Display

Subject: **D-1 SERIAL INPUT SIGNAL NOISE**

Model: **BKM-2085-14**
BKM-2085-20

Figure 1

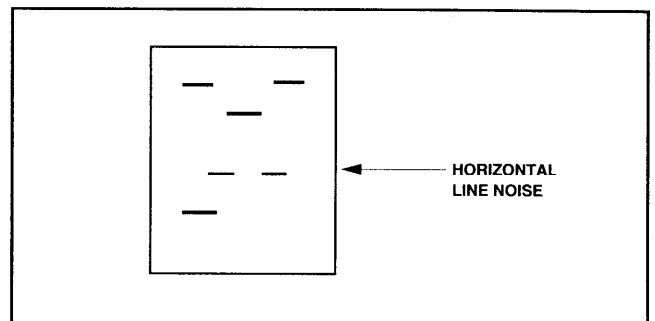
When a serial component digital video input signal is selected, an error at the serial-to-parallel converter may cause horizontal screen noise (see Figure 1). To minimize this effect, perform the following modification procedure.

Figure 2

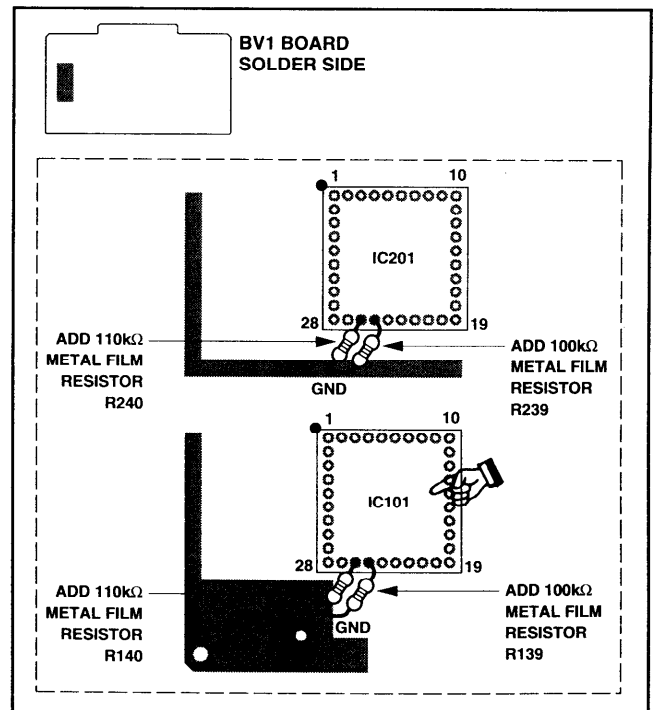
MODIFICATION PROCEDURE BV1 Board, Solder Side (See Figures 2 and 3.)

- Solder 100k Ω metal film resistor between
 - IC101-25 and GND
 - IC201-25 and GND
- Solder 110k Ω metal film resistor between
 - IC101-26 and GND
 - IC201-26 and GND
